हिन्दुस्तान पेट्रोलियम HP इंजीनियर्स इंडिया लिमिटेड ENGINEERS INDIA LIMITED (A Govt. of India Undertaking)	**Residue Upgradation Facility (RUF)** **EPCC-3 Package for** **Visakh Refinery Modernization Project (VRMP)**	L&T Hydrocarbon Engineering **L&T- CHIYODA LIMITED**
Title: ~~Data~~ Civil drawing for Dock Leveller (504-LZ-930 A/B) **Doc. No.: B016-RUF-LT-504-MP-DW-NTPL(1)-13005**		**Rev. No.: 00** **Page No: 1 of 4**

DATE: 31.05.21 | SCALE: 1:1
TITLE: CIVIL DRAWING FOR DOCK LEVELER (504-LZ-930A/B)
DEPT: DESIGN
DRN BY: SMS
CHK BY: VJ
APP BY: AK
PROJECT: L&T-RUF
PWO NO.:
DRG. NO.: B016-RUF-LT-504-MP-DW-NTPL(1)-13005
SH.: 1 OF 2
REV.: 00
CAD REVISE THIS DRG. USING CAD SYSTEM ONLY FILE:

DATE 29.5.21 | SCALE 1:1 | TITLE: CIVIL DRAWING FOR DOCK LEVELER
DEPT: DESIGN
DRN BY: SMS | PROJECT: L&T-RUF | DRG. NO.: B016-RUF-LT-504-MP-DW-NTPL(1)-13005 | SH. 2 OF 2
CHK BY: VJ | PWO NO.: (504-LZ-930A/B) | REV. 00
APP BY: AK | CAD WORK THIS DRG. USING CAD SYSTEM ONLY | FILE:

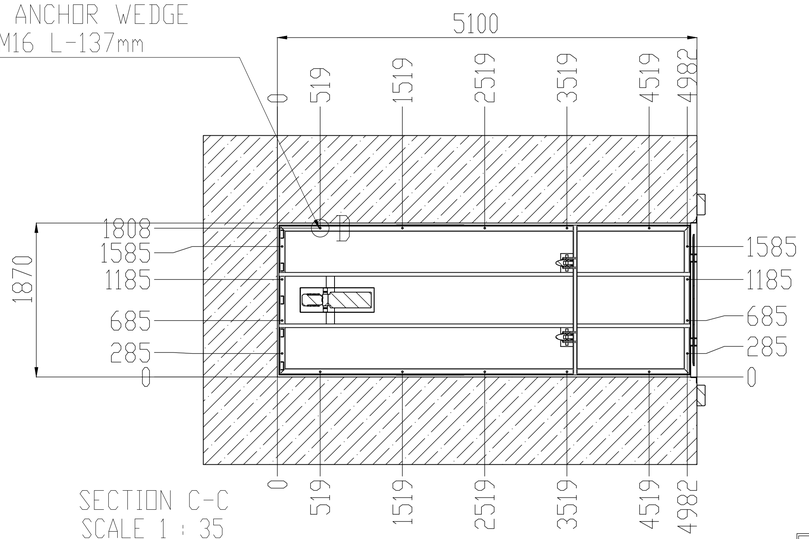
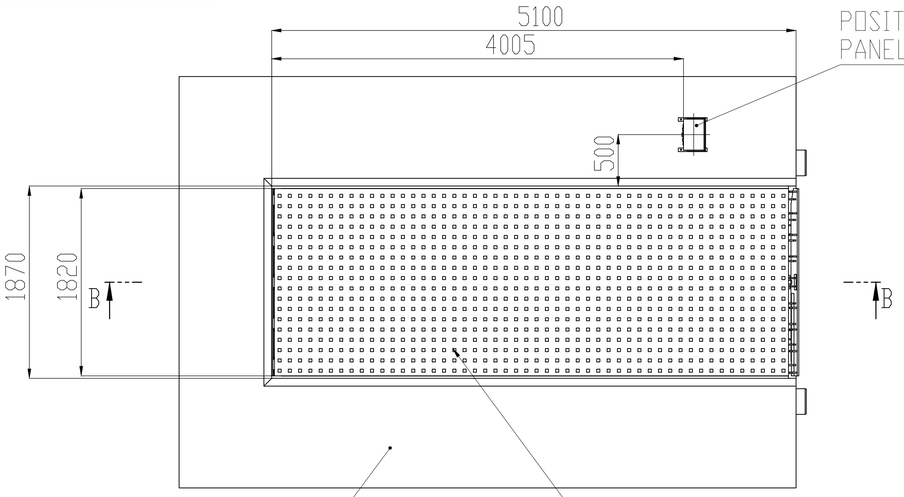
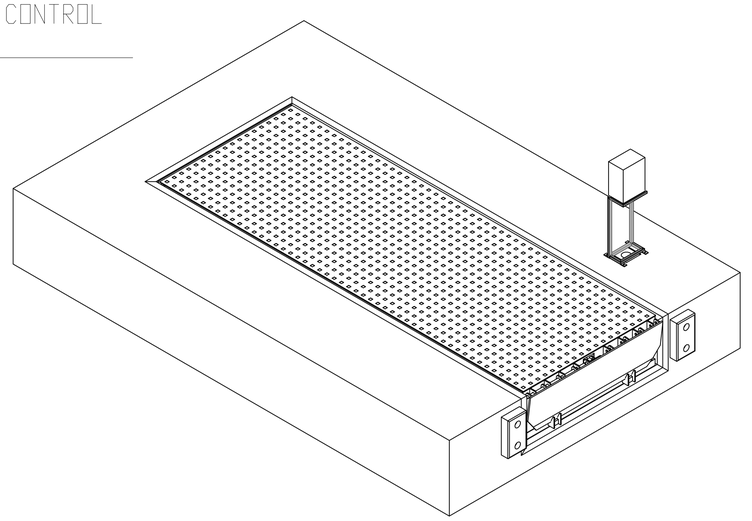
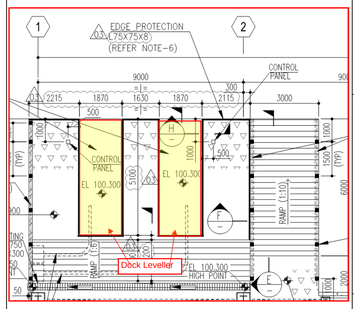
EIL Comments:
1. Include a sheet showing both dock levellers together for clarity w.r.t. relative location.
2. Tabulate BOM for one no. dock leveller.
3. "Client" wherever mentioned in the drawing shall be replaced by "LTHE".
4. Other comments as marked.

List here "GAD for Dock Leveller (504-LZ-930A/B)"

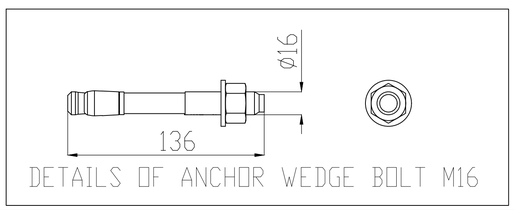
Please update the below as Product Description.

PROJECT DESCRIPTION -
1. DOCK LEVELER - PIT MOUNTED ELECTRO-HYDRAULIC TYPE
2. CAPACITY- 6 TON POINT LOAD
3. QTY- 2 NOS
4. PRODUCT SIZE- 5100mm(L)X1820mm(W)X600mm(D)
5. PIT SIZE-5100mm(L)X1870mm(W)X600mm(D)

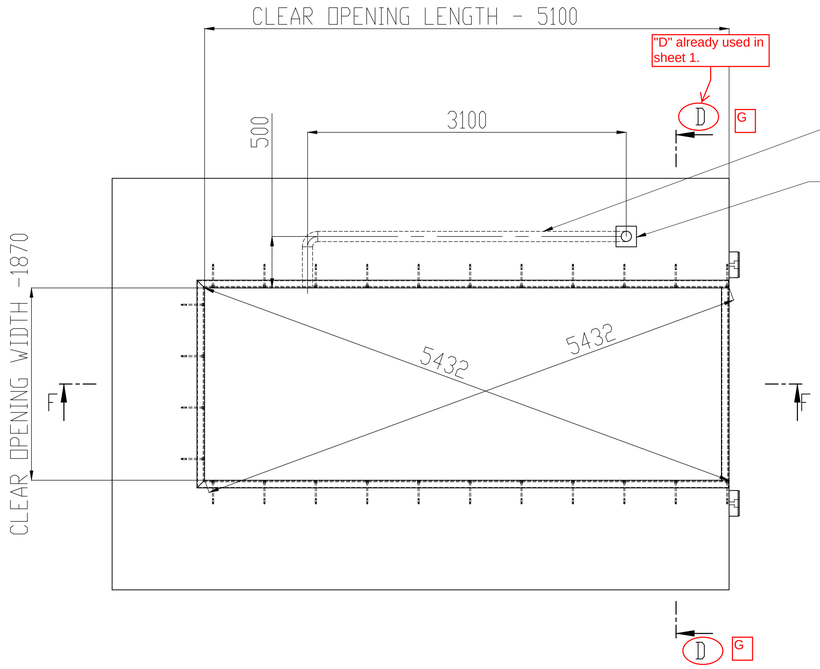
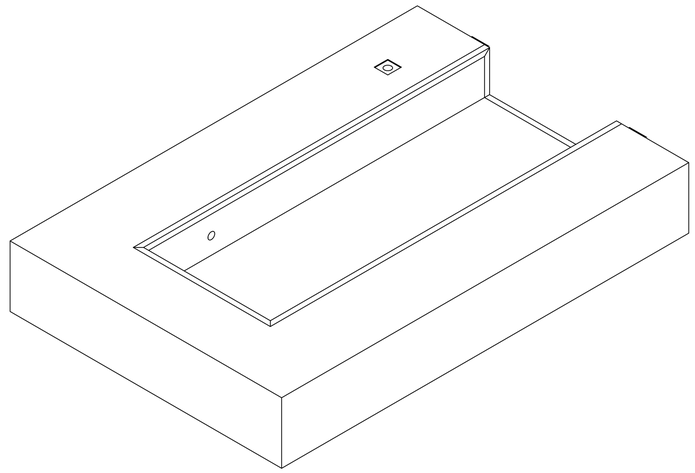
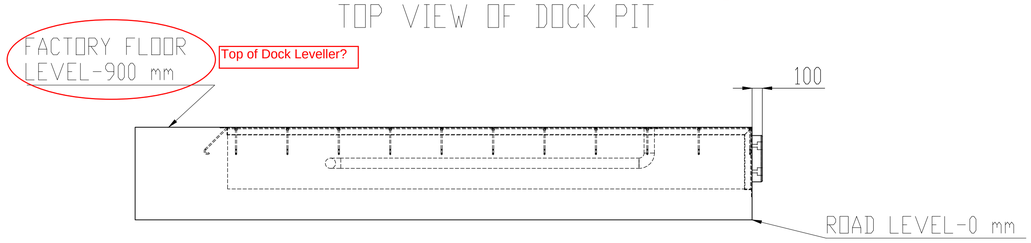
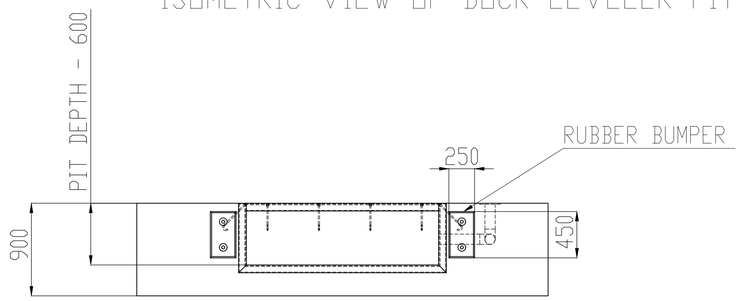
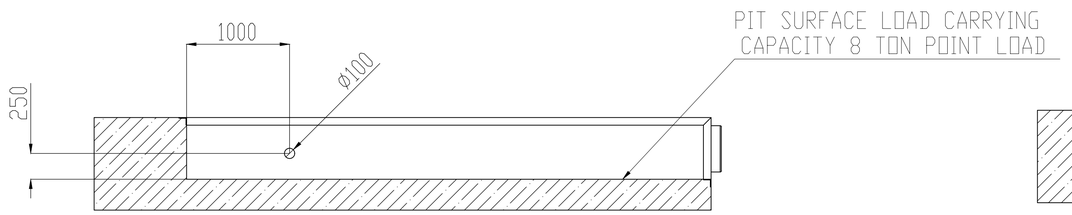
EIL Comments:
1. Refer comments marked on sheet 1 of 2.
2. Other comments as marked.

NOTES -
1. PIT & ALL CIVIL WORK IS ~~CLIENT~~ LTHE SCOPE .
2. AT ALL EDGES OF PIT ANGLE 75X6 MM THK(ANGLE IN CLIENT SCOPE) TO BE ANCHORED IN CONCRETE .
3. PIT SURFACE SHOULD BE PLAIN & LOAD CARRYING CAPACITY FOR PIT SURFACE SHOULB OF 8 TON POINT LOAD .
4. MINIMUM 4 INCH DUCT DUCT TO BE PROVIDED FROM CONTROL PANEL TO PIT OPENING BY CLIENT FOR ELECTRICAL CABLE ROUTING . REQUIRED DUCT IS IN CLIENT SCOPE.
5. CONTROL PANEL IS PROVIDED WITH ELECTRICAL CABLE LENGTH OF 5 METER AS STANDARD . CONTROL PANEL SHOULD BE LOCATED NEAR DOCK LEVELER FOR EASY VIEW OF LIP RESTING ON VEHICLE .
